**NUMBER:** 24-007-11

**GROUP:** Heating & Air  
Conditioning

**DATE:** August 09, 2011

Whistle Or Rattle Sound From Dash While HVAC Is Operating In Panel Mode

***Fig. 2 AC Liquid And Suction Line***

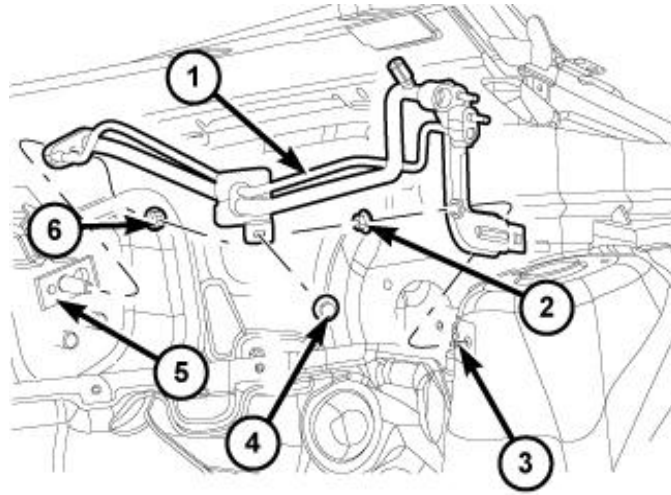
To correct this condition the service port was moved from the A/C suction and liquid line to the A/C suction line.

1. Replace the A/C suction and liquid line. Refer to the detailed procedures available in DealerCONNECT/TechCONNECT group 24 - Heating & Air Conditioning > Plumbing > Line, A/C liquid Removal and Installation ([Fig. 2](#)).

**Fig. 3 AC Suction Line**

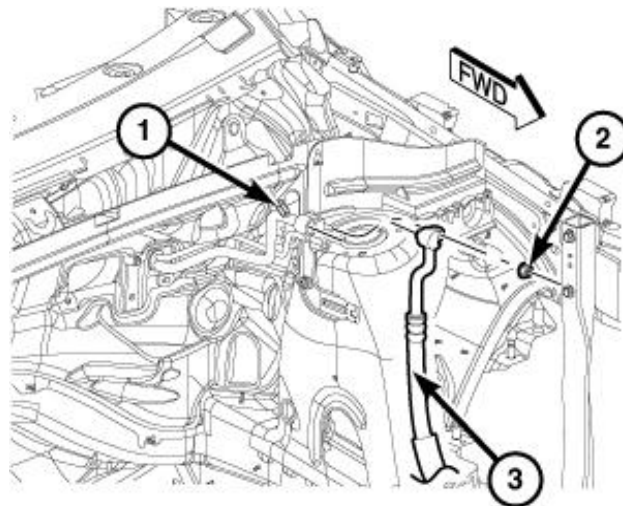
2. Replace the A/C suction line. Refer to the detailed procedures available in DealerCONNECT/TechCONNECT group 24 - Heating & Air Conditioning > Plumbing > Line, A/C Suction Removal and Installation ([Fig. 3](#)).
